St Aloysius' College Redevelopment Modification 4

Stage 1 design change

State Significant Development Modification Assessment (SSD-8669-MOD-4)

March 2023

Figure 4 | Third floor modification (Source: Applicant's additional information 2023)

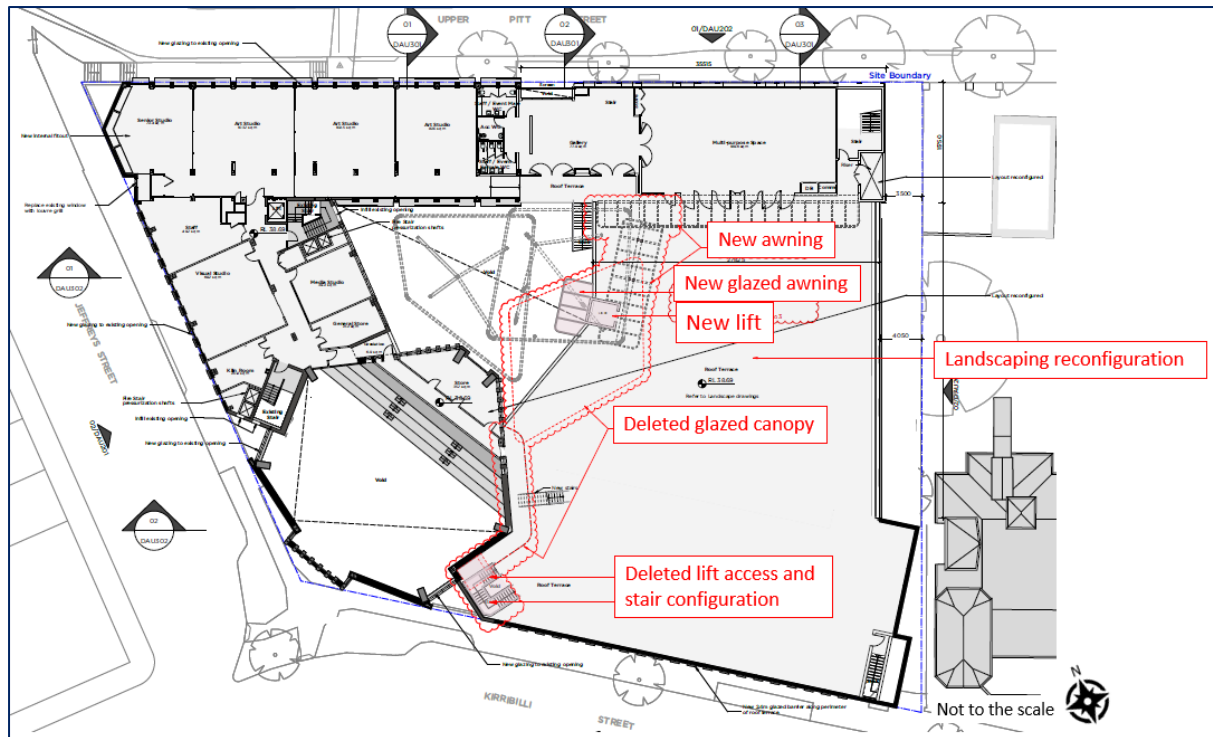
Third Floor (LV3)	<ul style="list-style-type: none">• Removal of southern side lift access to roof area.• Addition of new lift to centre of the building to access to the roof area.• Addition of new glazed awning adjacent to new lift.• Reconfiguration of stairs on the southern side.• Deletion of approved glazed canopy.• Minor alterations to the chapel wall adjacent to the lift to the south.

The modification application proposes to alter the internal layout on several levels of the Main Campus building within the site as identified in **Figures 2 - 6**. The Applicant has advised that the modifications are proposed to reflect detailed internal fitout, better functional arrangements and design development.

The Department is satisfied that the internal works are acceptable as the bulk and scale or the building footprint of the Main Campus building would not be impacted by the proposed changes.

Figure 6 | East Elevation showing location of the approved and new lifts (Source: Applicant's additional information 2023)

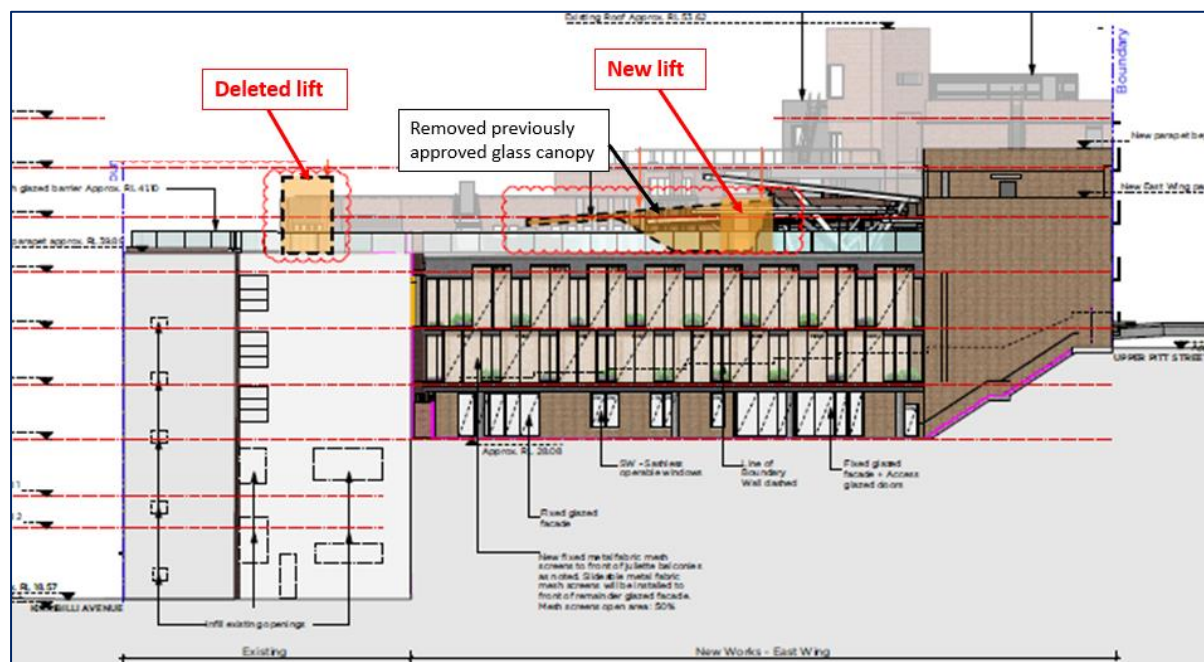
- reduce service levels of the southern side lift from Lower Ground Floor 3 (LGF 3) to LV1 (previously this lift was approved from LGF3 to roof terrace LV3).
- addition of a new lift at centre of the building to service LV1 to LV3.

Additionally, the reduction of service level of the southern side lift would be a positive outcome as it would decrease the building height, as viewed from the southern public domain.

The Department considers that the proposed modification to approved lift on the southern side and addition of a new lift would not result in detrimental impacts to the surrounding neighbouring properties, would remain compatible with the overall design quality of the development, would not detract from the quality of the streetscape and would assist in providing the functional needs of the school. The new lift would not be visible from any street frontage.

The Department has recommended deletion of Schedule 3 Condition B3(d), as the glazed lift at the southern end would no longer serve LV3.

Figure 7 I Modified rooftop landscape plan (Source: Applicant's additional information 2023)

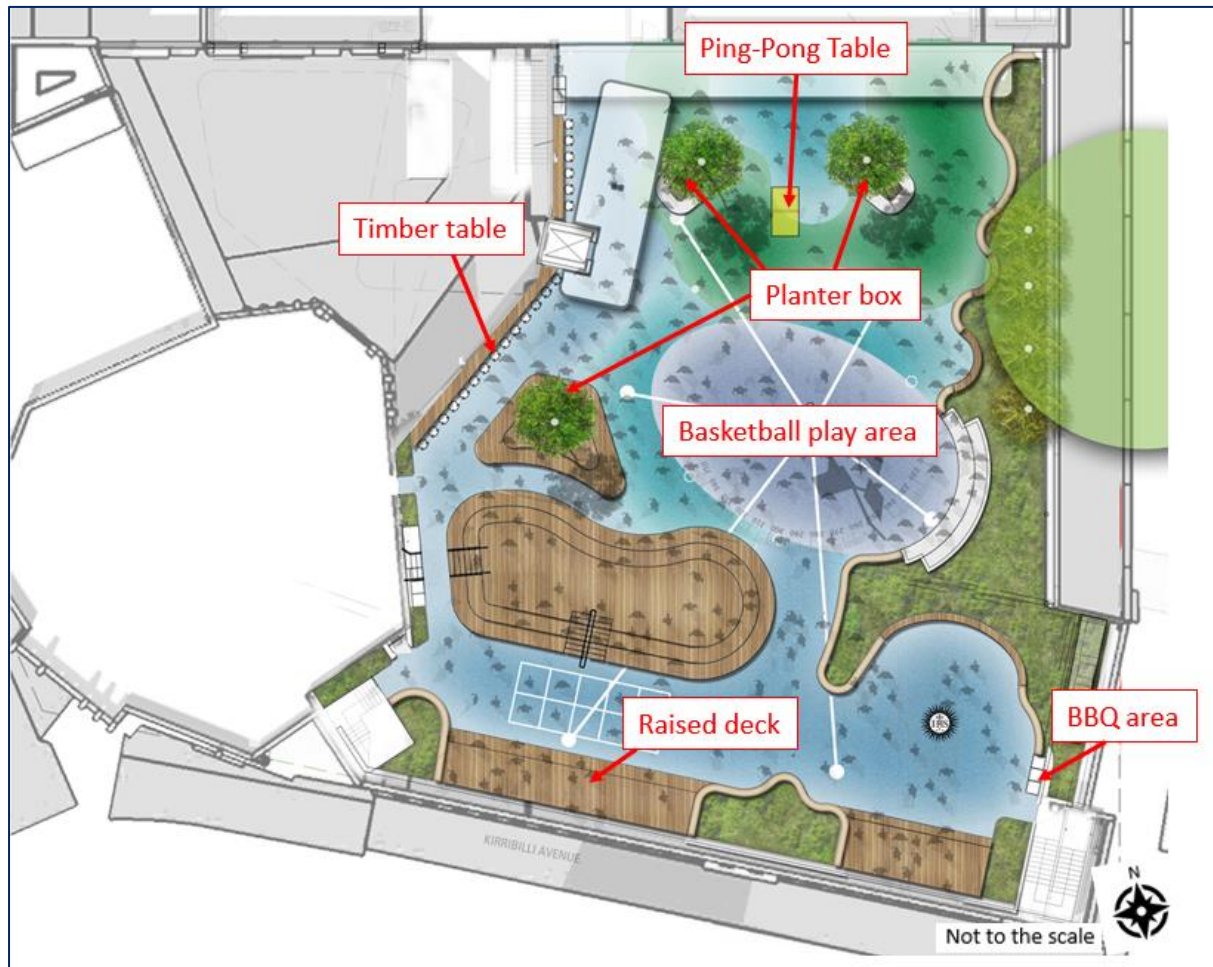
- reconfiguration of an approved timber table to extend to the new lift.
- relocation of BBQ area.
- reshaping of a raised deck to the south.
- relocation of two planters near the Ping-Pong table and deletion of one planter.
- reorientation and change in the size of the approved basketball play area.
- redesign of the planter box near the timber table.
- additional planting on the eastern side of the roof.

The modified landscape plan ensures compliance with this condition and proposes some additional amendments as itemised in **Section 2.3** and indicated in **Figure 7**.

The Department considers that the proposed landscaping amendments would not result any amenity impacts on the neighbours, nor result in non-compliance with the requirements of Schedule 3 condition B5 (discussed later). It would ensure that the rooftop space is a vibrant and useable area that allows the children open space to play and learn in.

The Department has assessed the modified landscape drawings and recommends that Schedule 3 condition B5 be amended to be consistent with the submitted landscape plan to be listed in Schedule

3 condition A2 (approved drawings). The recommended amendments to the condition are discussed in **Table 4**.
